Fire Safety Standards Advisory Group (FSSAG)
Matter Discussed in the 62nd FSSAG Meeting held on 19 May 2020

1 *Review of the Requirements for Emergency Lighting*

**CIRCUIT ARRANGEMENT FOR FIRE DETECTION AND ALARM DEVICES USING AS
AUTOMATIC FIRE DETECTION AND AUTOMATIC ACTUATING DEVICES (ADDRESSABLE SYSTEM)
BY SHORT CIRCUIT ISOLATOR**

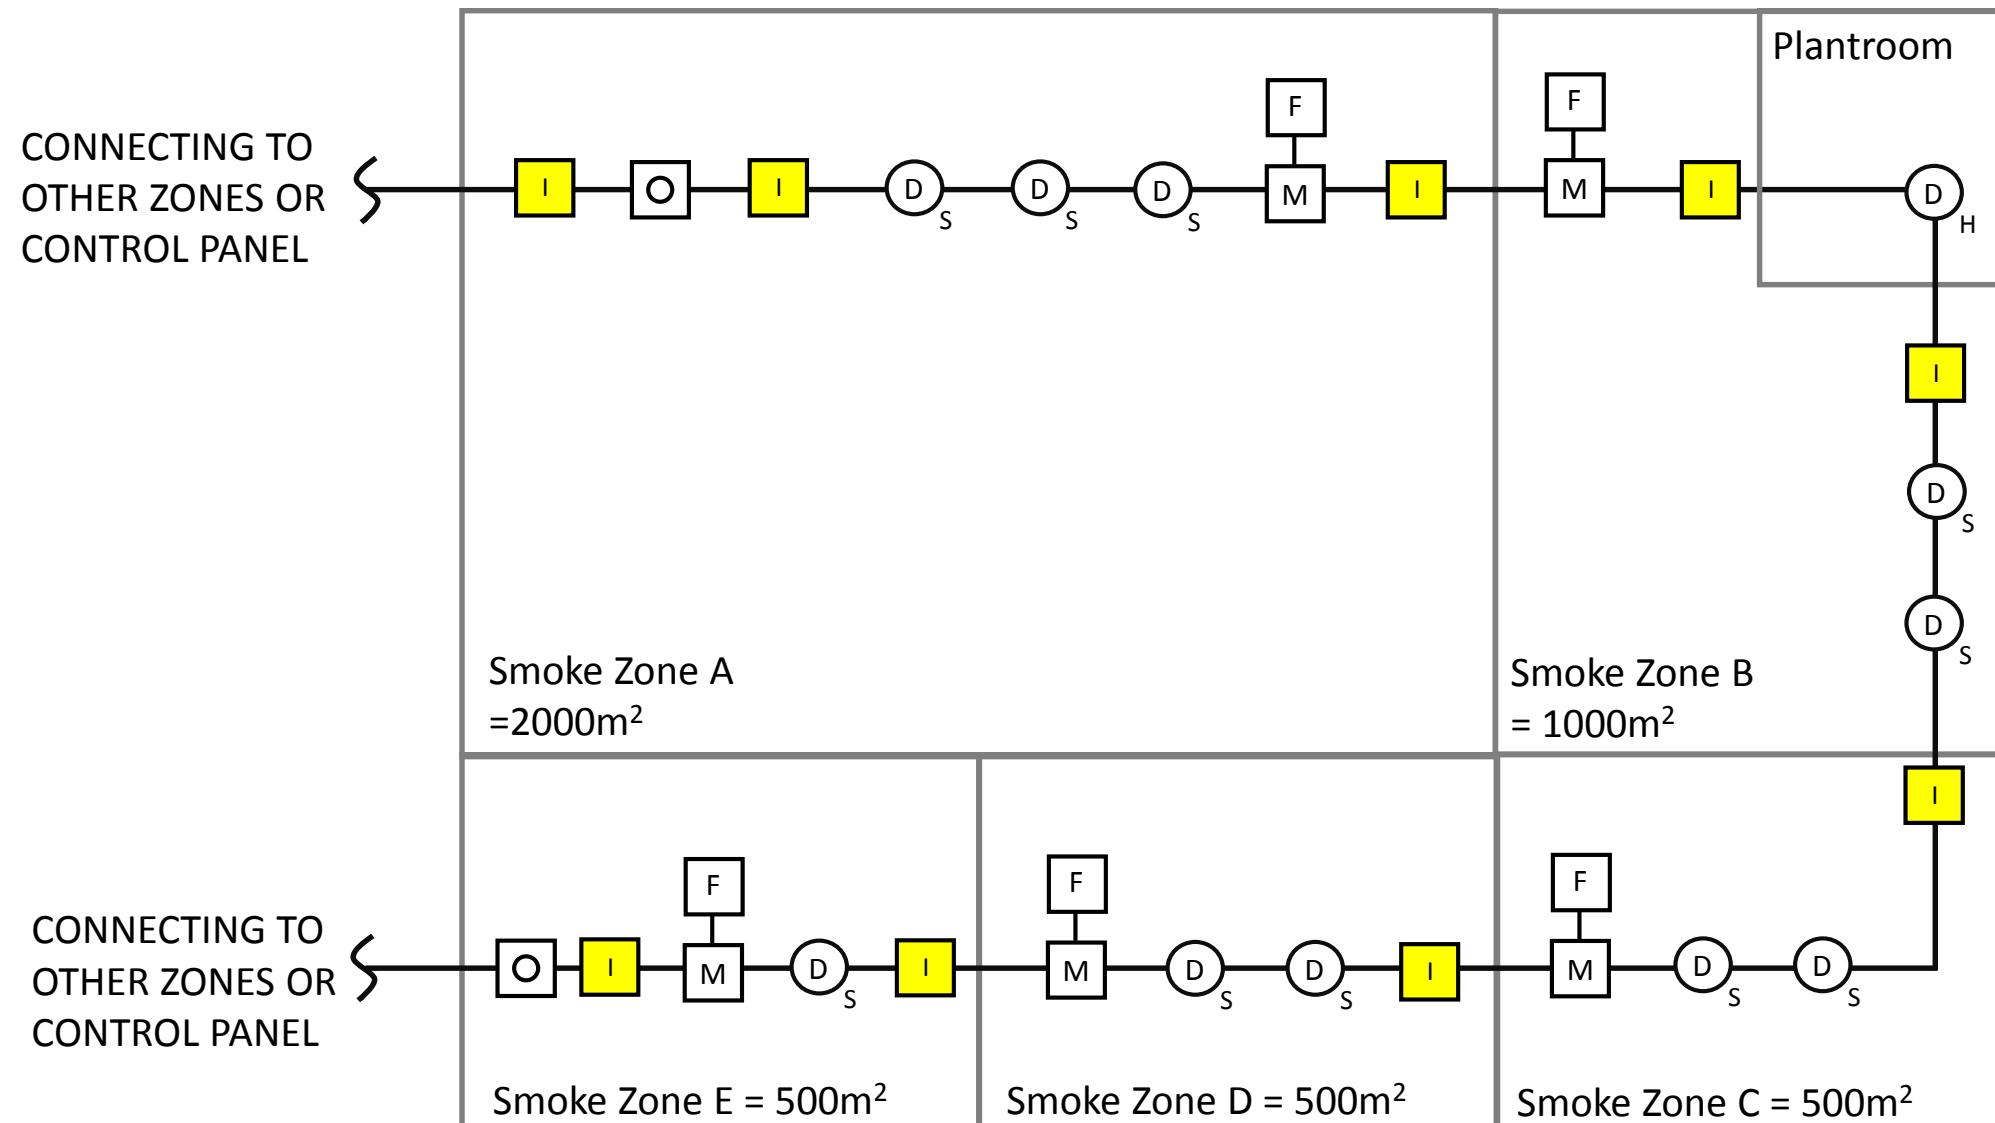
The proposal of this item had been agreed in last meeting. Minor textural amendments were made on the proposed diagram after meeting. This diagram would be recorded as final one and attached to the meeting minutes of this meeting to serve as an official record.

As no further comments on the final diagram had been received in the meeting, the proposed diagram was the final one. In the circumstances, members agreed that the item would be deleted in the next meeting.

GENERAL CONFIGURATION FOR CABLE / BUSDUCT ARRANGEMENT BETWEEN MSB AND SSB FOR FSI

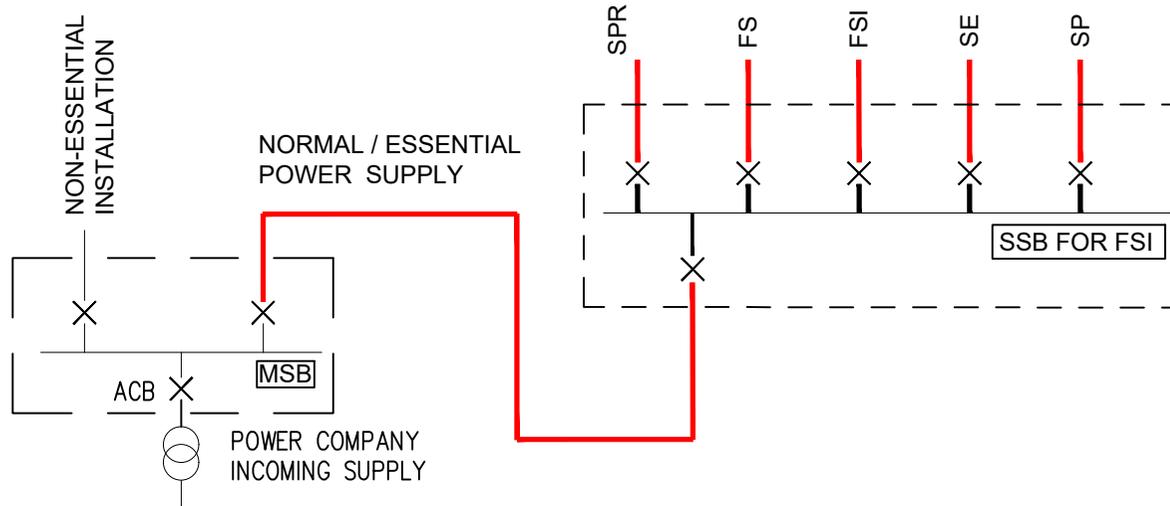
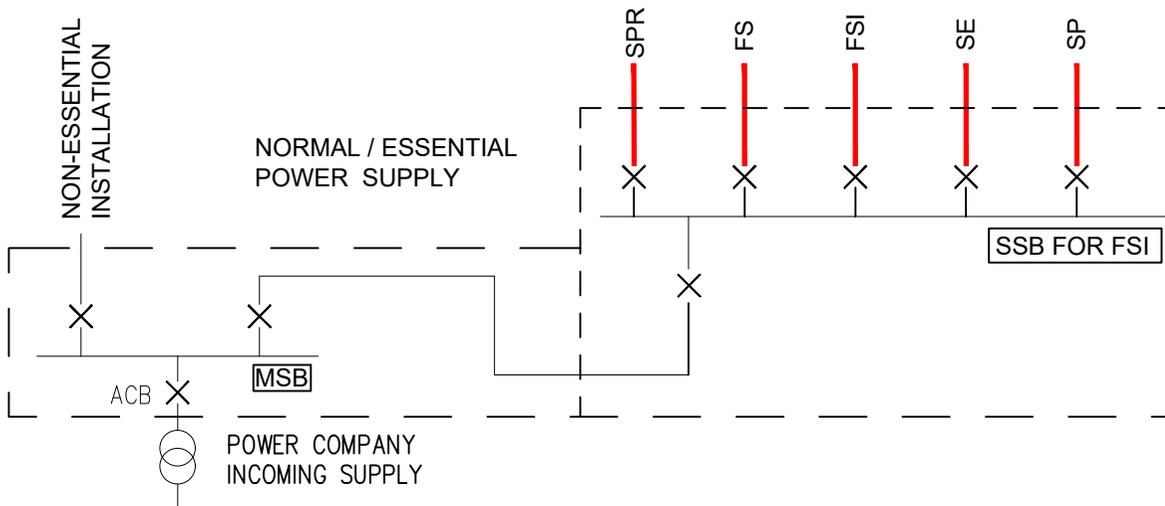
The principle of fire resisting cable application between the main switchboard and sub-switchboard for FSIs had been discussed and agreed in last FSSAG meeting. The fine-tuned schematic diagram on FR cable connection had been recorded as final one as no further comments from other members received.

As no further discussion on the issue was required, members agreed that the item would be deleted in the next meeting. The diagram would be attached to the minutes of meeting.
